Wisconsin Department of Transportation

Proposal #40: 7040-01-73, WISC 2016 500
C Loyal, South and Main Streets
Helm Street to Elm Drive
STH 98
Clark County

This is Addendum No. 01, which provides for the following:

ADDENDUM NO. 01

Addendum No. 01
 ID 7040-01-73
 Revised Sheet 24
 December 7, 2016

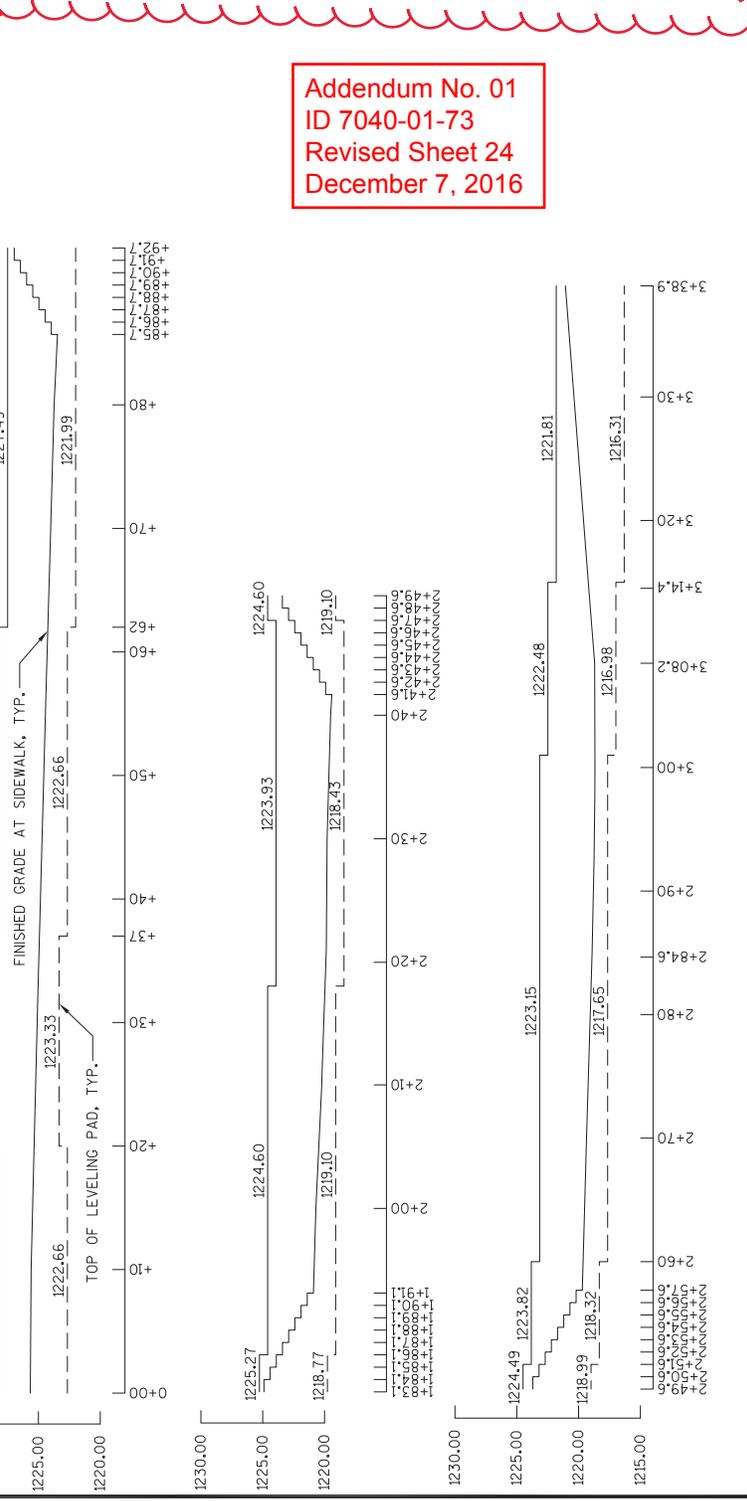
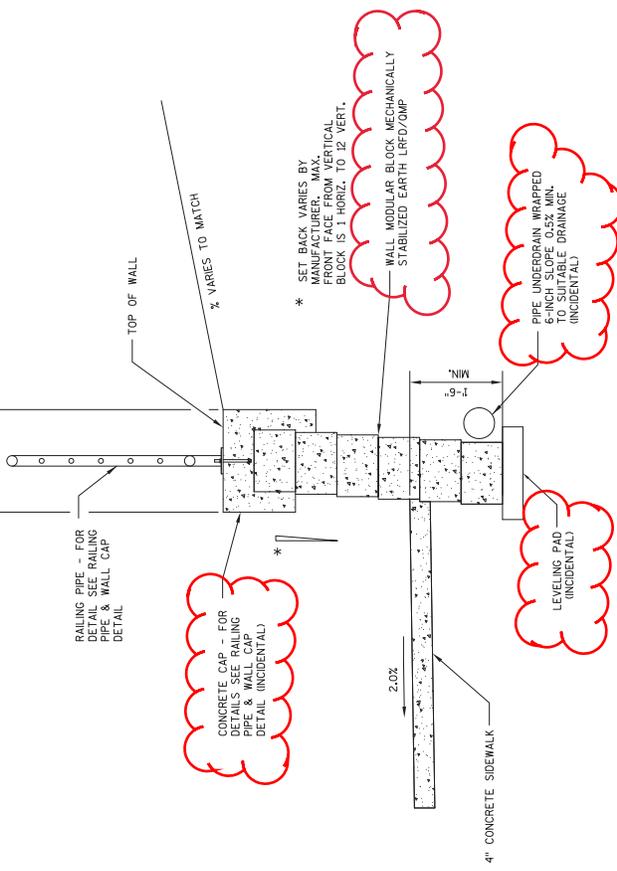
Revised Plan Sheets	
Plan Sheet	Plan Sheet Title (brief description of changes to sheet)
24	Retaining Wall switched from "Wall Concrete Panel Mechanically Stabilized Earth LRFD/QMP pilot" to "Wall Modular Block Mechanically Stabilized Earth LRFD/QMP"
25	Retaining Wall switched from "Wall Concrete Panel Mechanically Stabilized Earth LRFD/QMP pilot" to "Wall Modular Block Mechanically Stabilized Earth LRFD/QMP"
164	Bid item Quantity change for 204.0100
168	Bid Item name change on SPV.0165.01
169	Bid Items added (SPV.0090.16, SPV.0090.17, 416.0260)
